# Access Compliance Report

## Public Rights-of-Way

Intersection ID: 43496	Main Street: PROVENCE_LN	Cross Street: CHESLEY_DR	Location: SW
ADA ID: 92F3824F1242	Ramp Type: PerpDiag	Initial Pass/Fail: Fail	Overall Compliance: No
Codes/Mitigation Info/Possible Solution		Field Measurements/Component Compliance	
Severity Score: 46.25

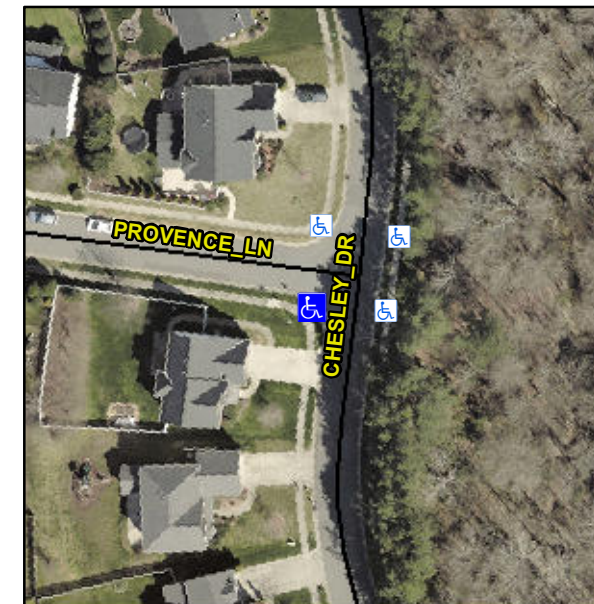
**Not Found, R304.5.1, R304.2.2, R304.5.3**

Compliance	Description	Data	Compliance	Description	Data
N/A	Ramp Length (in)	48.0	No	Ramp Slope (%)	11.4
No	Ramp Width (in)	41.0	No	Ramp XSlope (%)	7.4
N/A	Flare Type LT	N/A	N/A	Flare Type RT	N/A
N/A	Flare Slope LT (%)	N/A	N/A	Flare Slope RT (%)	N/A
N/A	Flare Traversable LT?	N/A	N/A	Flare Traversable RT?	N/A
N/A	Landing Length (in)	N/A	N/A	DWS Provided?	N/A
N/A	Landing Width (in)	N/A	N/A	DWS Contrast?	N/A
N/A	Landing Slope (%)	N/A	N/A	DWS Length (in)	N/A
N/A	Landing X Slope (%)	N/A	N/A	DWS Full Width?	N/A
N/A	Landing Curb? (Y/N)	N/A	N/A	DWS Offset (in)	N/A
N/A	Shared Landing?	N/A			
N/A	Gutter Ponding?	N/A	N/A	Gutter Slope (%)	N/A
N/A	Gutter Lip Ht (in)	N/A	N/A	Gutter X Slope (%)	N/A
N/A	Painted X Walk1?	No	N/A	Painted X Walk2?	No
	X Walk 1 Direction	To E		X Walk 2 Direction	To NE
N/A	X Walk 1 Width (in)	N/A	N/A	X Walk 2 Width (in)	N/A
	X Walk 1 Slope (%)	0.9		X Walk 2 Slope (%)	5.0
	X Walk 1 X Slope (%)	4.6		X Walk 2 X Slope (%)	1.8

**Remove & Replace Curb Ramp With Two New Directional Ramps or Equivalent.**
